## SITE PLAN REVIEW AND APPEARANCE BOARD

File No.: 2019-256-SPF-SPR-CLIII

Application Name: Pierre Delray Phase I (SunTrust Bank)

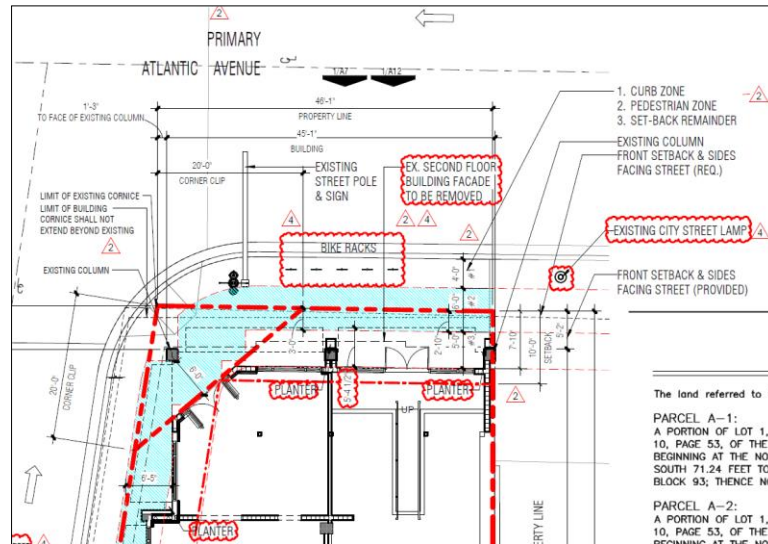
\*\*The applicant submitted a waiver request that will be considered by the City Commission on December 10, 2019, to reduce the storefront (front) setback from 10' to 7'-10" in order to increase the square footage on the ground floor and replace an existing arcade.

\*\*\*The building which has existed since 1929, has an existing non-conforming rear, side street, and front setback. LDR Section 1.3.5 (B)(1) says that "a nonconforming structure shall not be altered or enlarged in any way which increases its nonconformity, vertically or horizontally. Enlargement or alteration of the structure in a way that complies with applicable dimensional standards and does not create any new nonconformity, or alteration of the structure in a way that decreases the degree of nonconformity, is permitted.

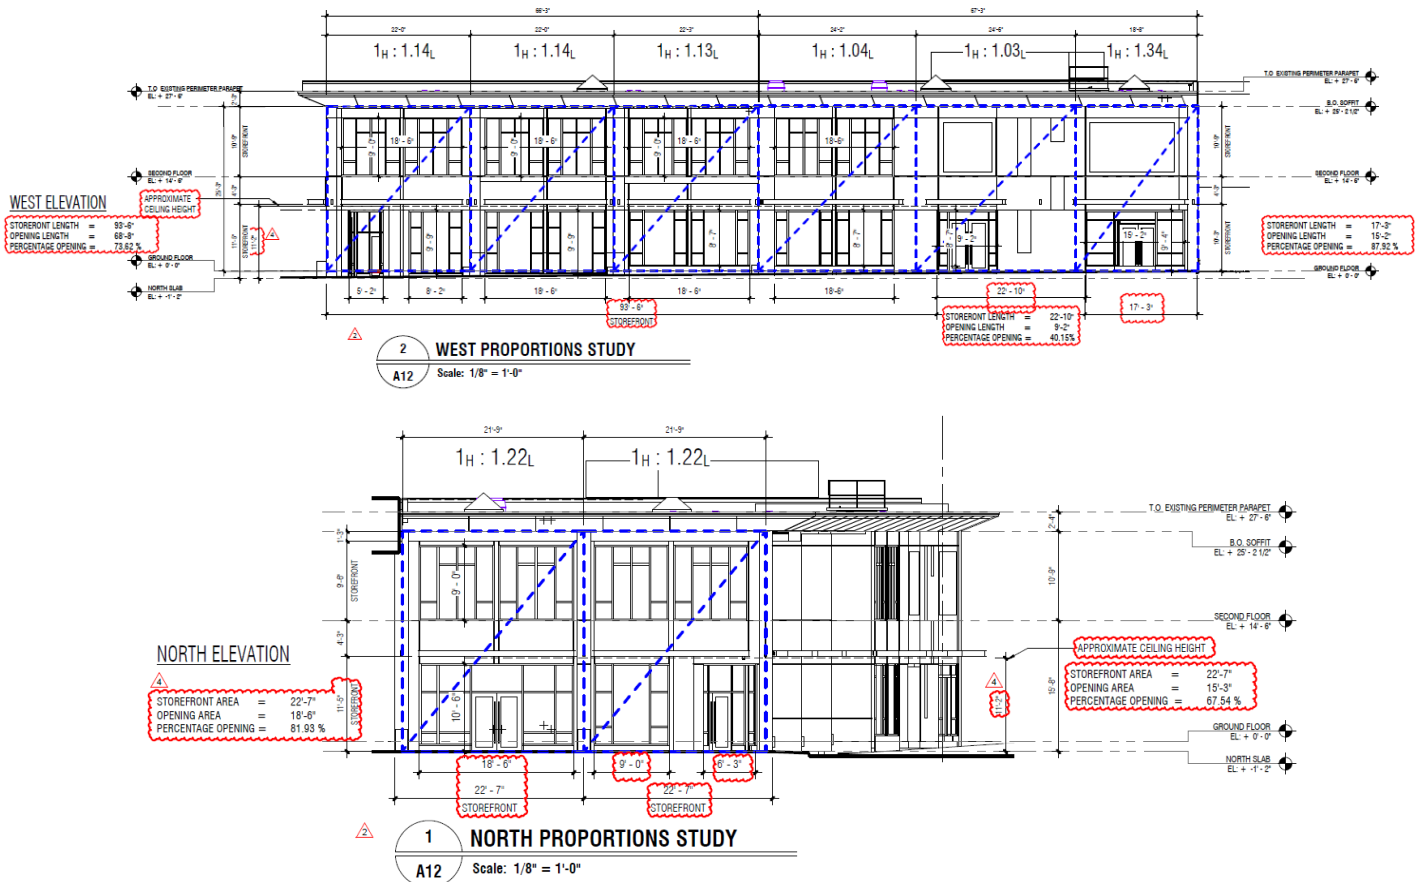
\*The applicant submitted a waiver request that will be considered by the City Commission on December 10, 2019, to reduce the storefront (front) setback from 10' to 7'-10" in order to increase the square footage on the ground floor and replace an existing arcade. The varying 6" to 6'-3" storefront setback on the west elevation adjacent to SE 3<sup>rd</sup> Avenue is existing and has remained since 1959.

\*\* The proposed design appears to maximize the amount of glazing possible. In some areas, the minimum 80% required openings where not able to be achieved due to non-conforming composition of the building and the structural columns.

\*\*\*The 3' wide awnings located on the bottom of the 2<sup>nd</sup> floor, project 5'-5" from the façade on the ground floor. The awning projection on the west side of the property varies from 2' to 5'-6". Some of the awnings proposed along the west elevation adjacent to SE 3<sup>rd</sup> Avenue are unable to project 5' from the façade due to possible encroachment into the travel lane of the road.

Northwest Elevation

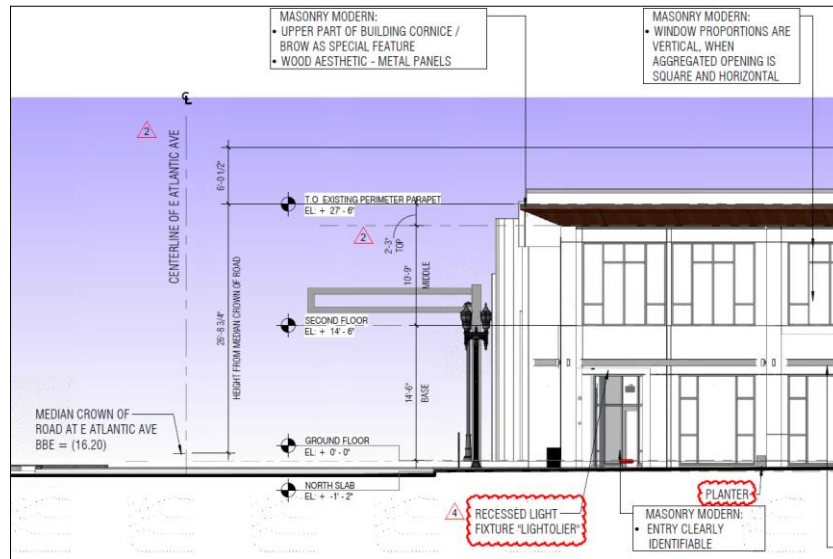
- The LDR requires that all buildings in the CBD have a Tripartite Composition (base, middle, and top). The Class III Site Plan modification proposes façade improvements to a building that was constructed in 1929. The façade improvements include a new modern storefront system that includes a 9" aluminum base, a second-floor middle, and a redesigned contemporary cantilever parapet roof top.

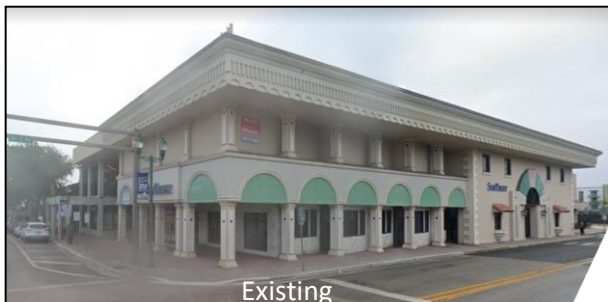
- The Pierre Delray I (SunTrust Bank) has existed since 1929. The existing design predates architect style guidelines listed in the Delray Beach CBD Architectural Design Guidelines (the Design Guide). The proposed "Masonry Modern" retrofit design includes a new storefront glazing for interior views of the building, metal awnings, chamfered roof top cornice act as shading devices for the building, cladded exterior columns that create articulations on the façade, and stucco, tile, and faux wood cladding. The new storefront system includes "Varicon" clear vertical glass glazing with powder coated gray aluminum framing. The awning proposed are pre-engineered aluminum canopies with a color to match the storefront. The exterior stucco wall will be painted with Sherwin Williams "Pure White." The design shows that the roof top cornice will be chamfered and will be cladded with Reynobond "Colonial Red" faux wood finished metal plans. The proposed renovation contain sustainable design practices such as retrofitting of an existing building, skylights to allow natural light and reduce artificial lighting, white wall painting to reflect surface heat, canopies and roof overhangs that would cast shade to reduce surface temperatures, a high efficiency air conditioning unit, and low flow plumbing fixtures.
